Fundamental Flaws in Southwest Path Lighting Proposal

SW path Lighting Proposal

Safety-Related Issues:

WisDOT recommends low glare fixtures; Project uses very **high glare** fixtures:

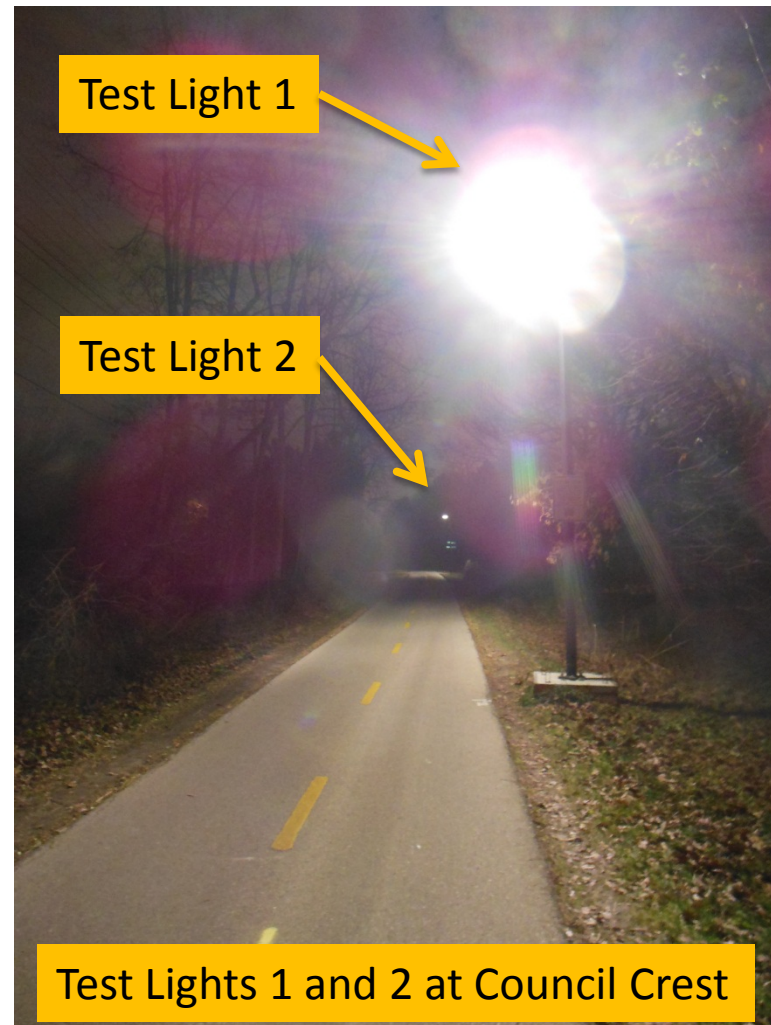
- Point Source Glare from fixture is very uncomfortable to walkers & bikers.
- A traveler looking straight down path from 20' away gets the same light in their eyes as they would looking straight Up into the fixture.
- WisDOT specifically recommends against glare-producing fixtures because they impact good vision at night.

Project:
(no overlap)
No Uniformity
More crashes

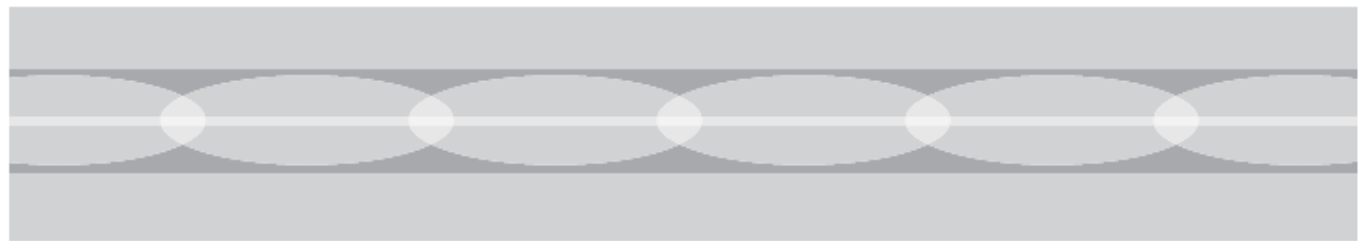
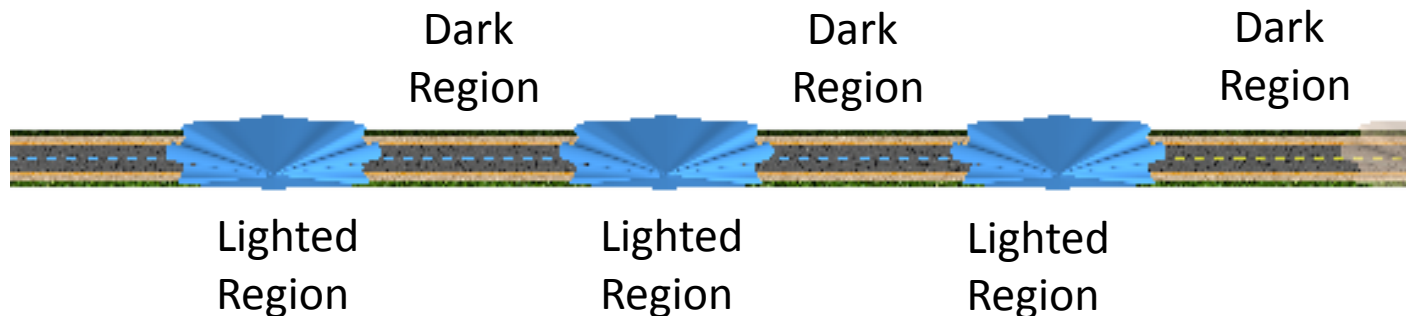
WisDOT Recommends uniformity, but Project is **very non-uniform**:

*“**Luminaire placement**: Uniformity of illumination is particularly important for shared-use paths. Bicyclists moving between “hot spots” from poorly placed luminaires may be unable to see in the interspersed shadows. Providing some overlap allows for a more constant visual environment, and **can help prevent crashes**”.*

Council Crest Test Light Pair (1 and 2); Walking NE

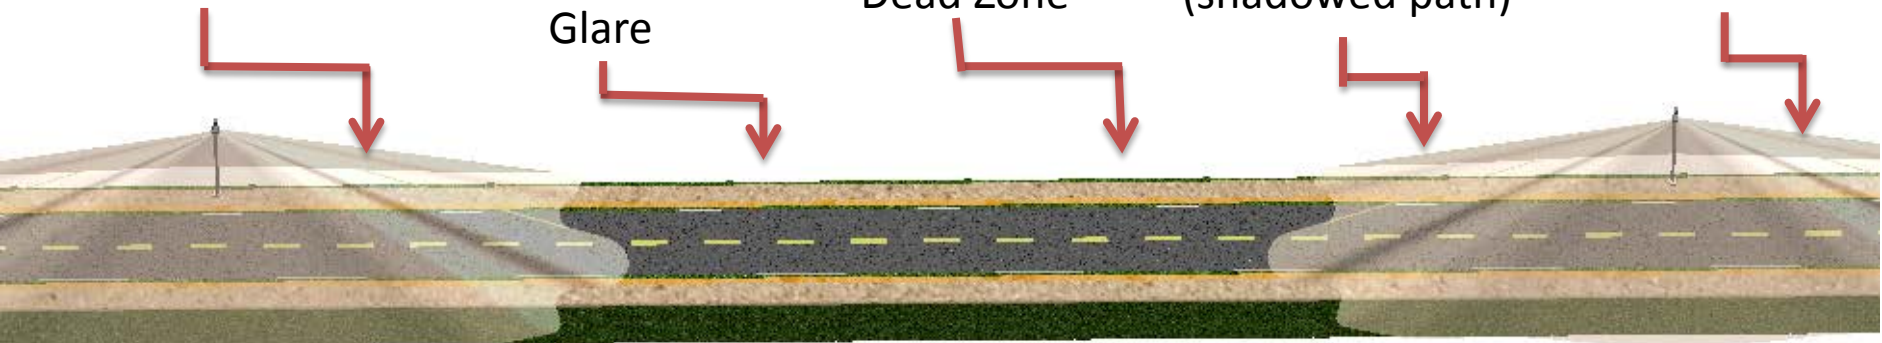
Project creates visual “Dead Zones”

High Glare

Increasing
Glare

Visual
“Dead Zone”

Back-lighting
(shadowed path)

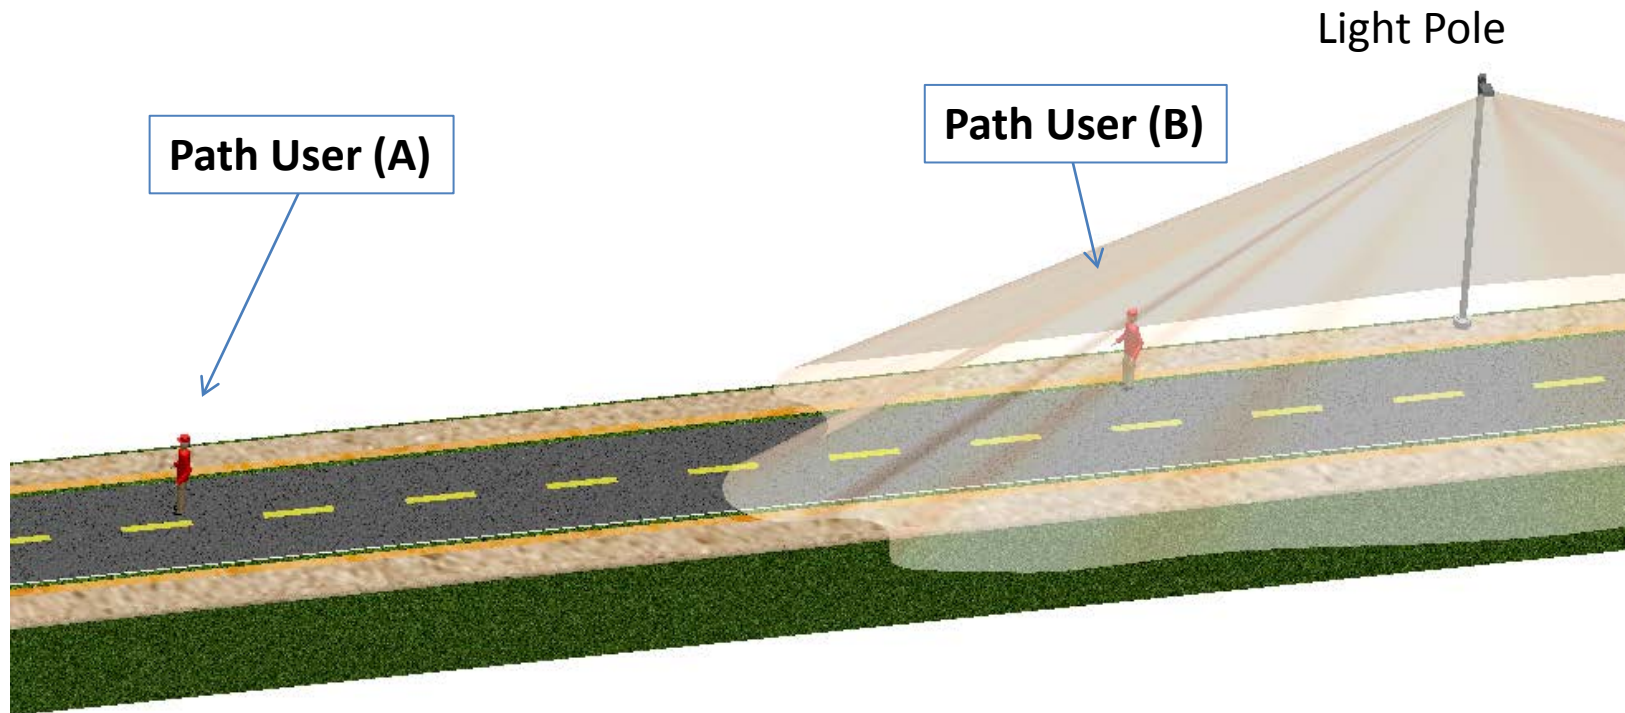
HYPE: “Project would help cyclists see debris or ice patches in the path”.

REALITY: Project effectively **obscures the path** in regions after each light because it casts a big, **deep shadow** (of path user’s own body) right in the worse place possible; directly in front of walker, runner or biker.

Picture from “Path User B” Location (see previous slide)

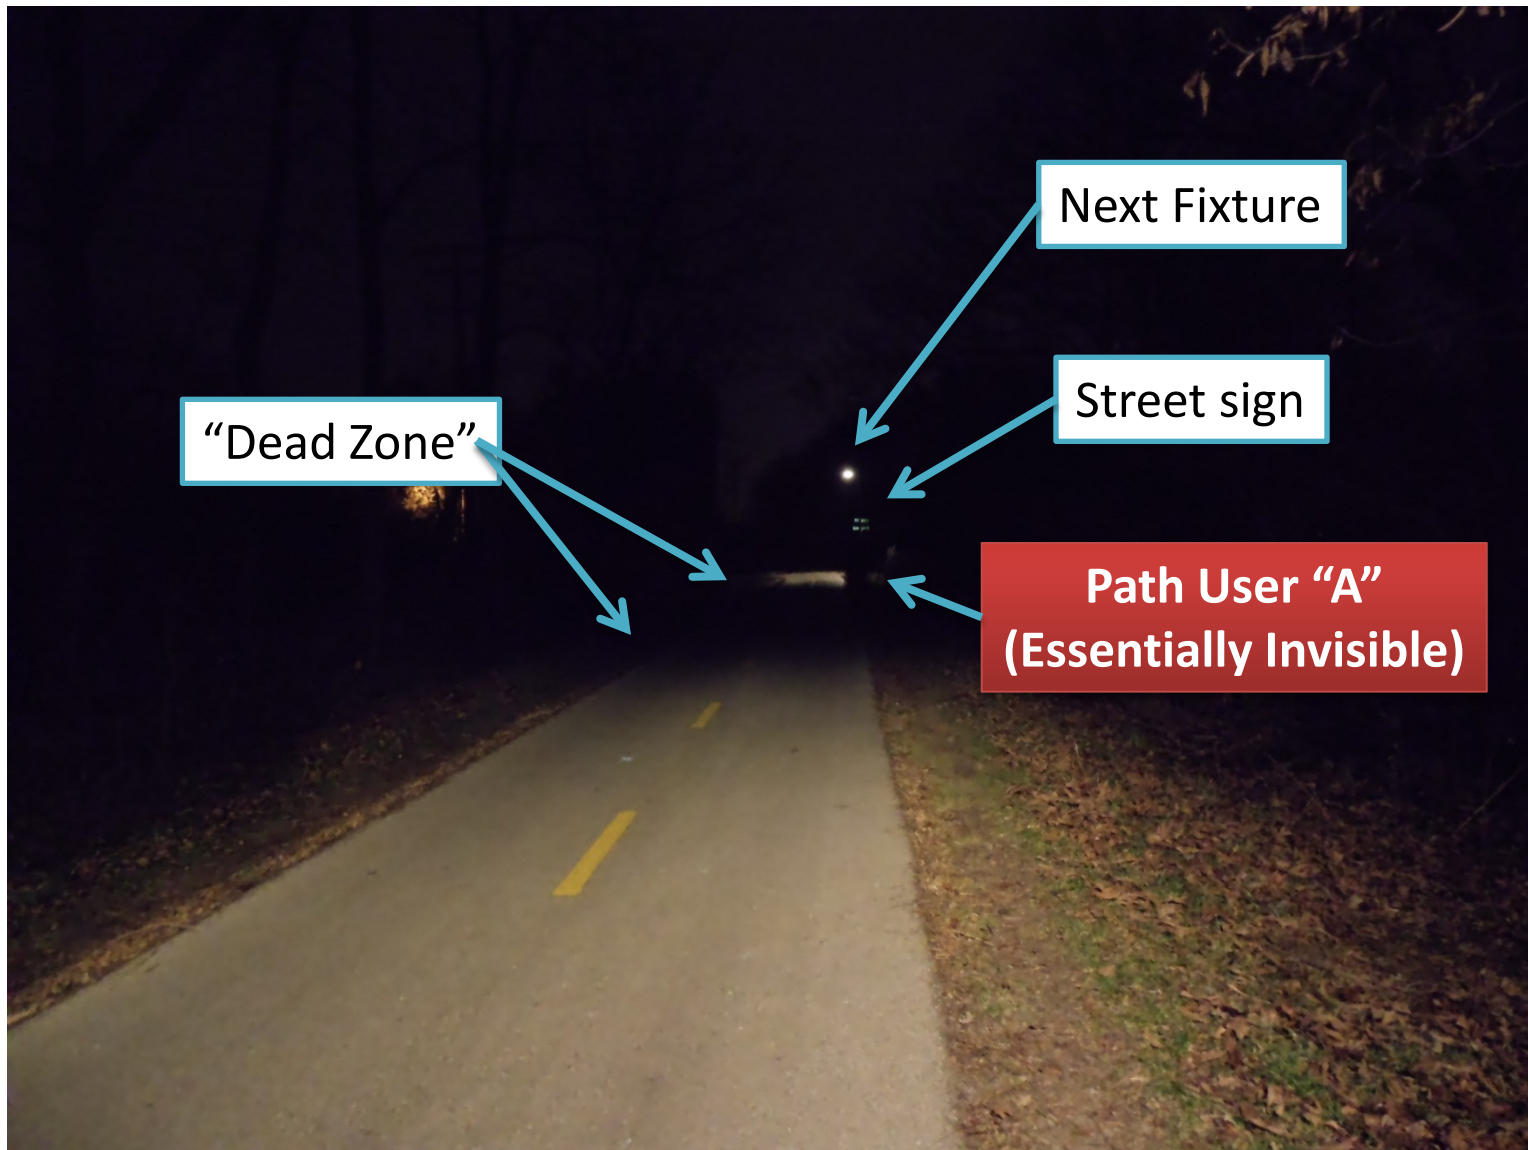
HYPE: “Project would help cyclists see dark-clothed pedestrians”.

Reality: Project Introduces new visibility hazard:
Path user (A) is difficult for Path User (B) to see because of B’s **loss of dark-adaptation** and A’s **relative darkness**.

-Scenario #1, covert victim selection-

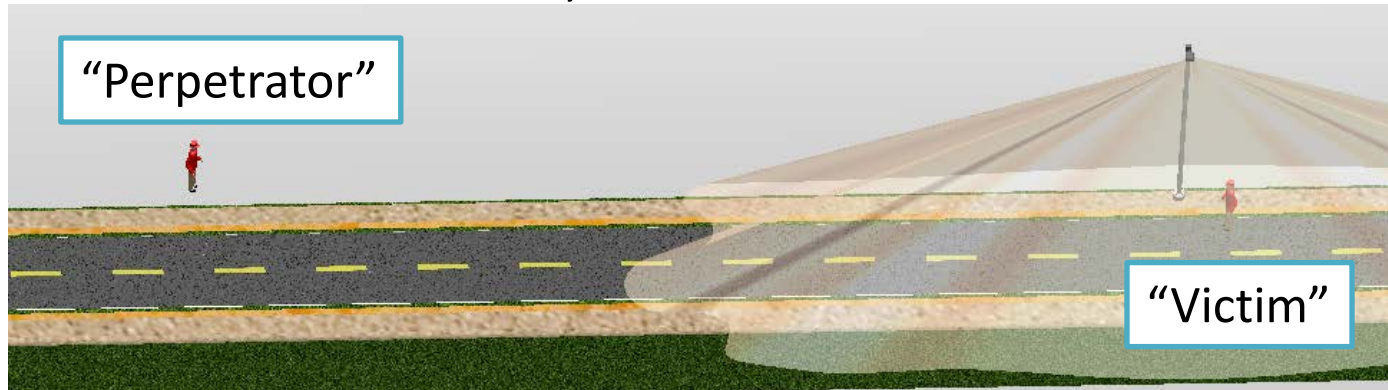
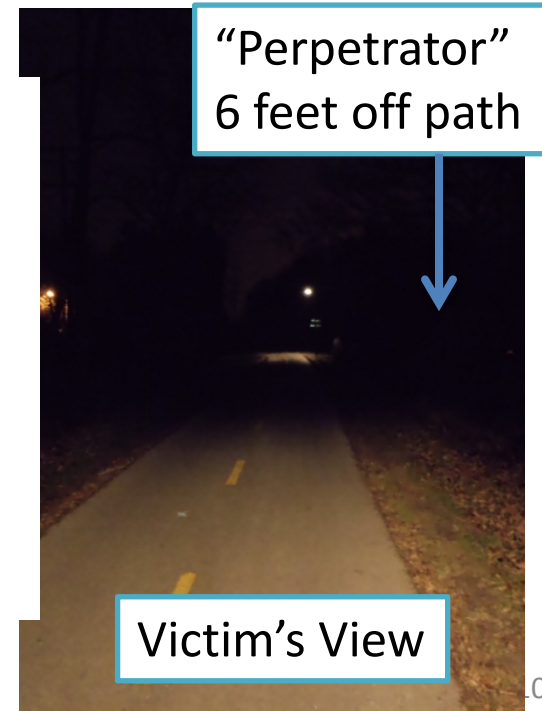
By standing off to the side of the path in any "dead zone", a "perpetrator" can easily view all passersby without being detected.

-Scenario #2, overt victim selection-

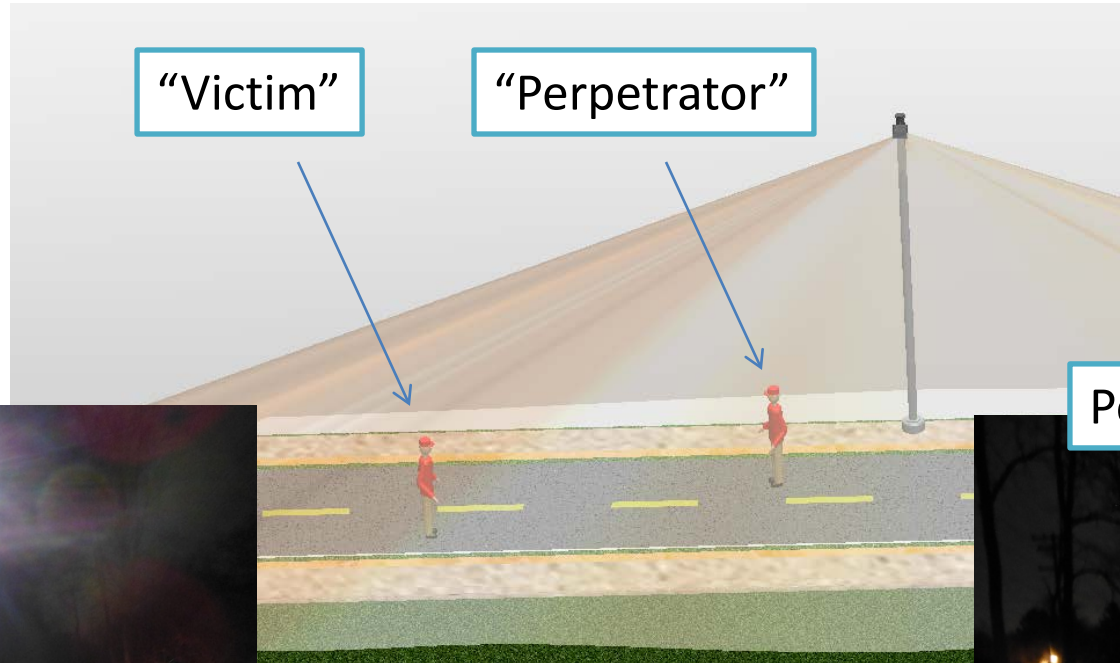
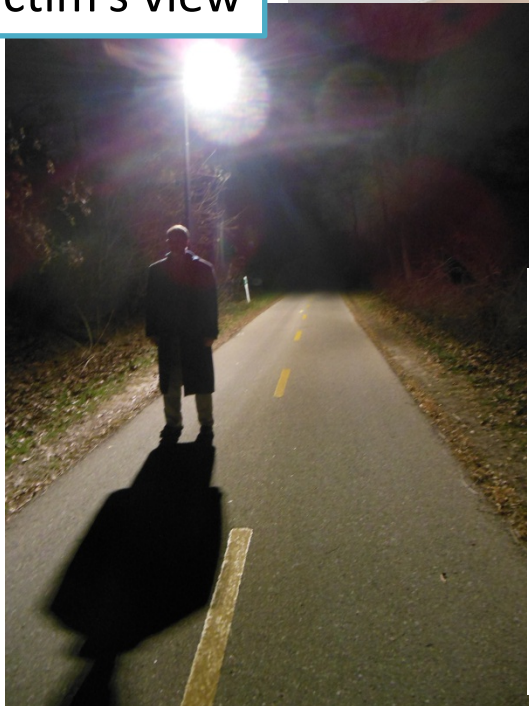
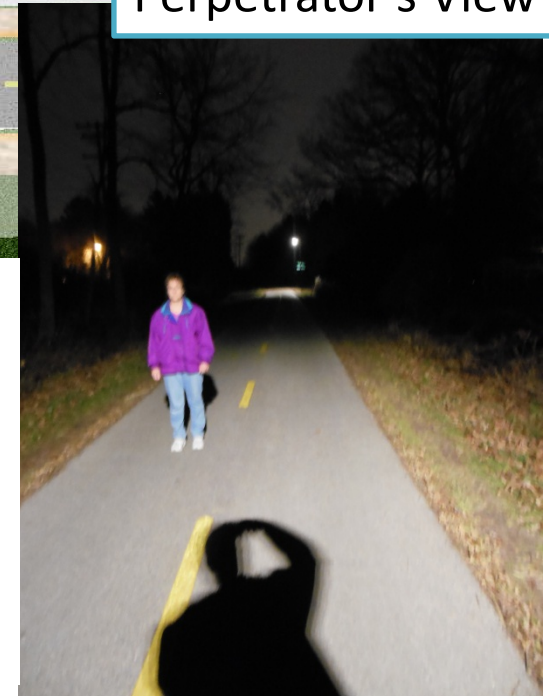
By standing "down stream" of any light, a person with ill-intent can easily arrange to have a visual advantage over others who are approaching on the path.
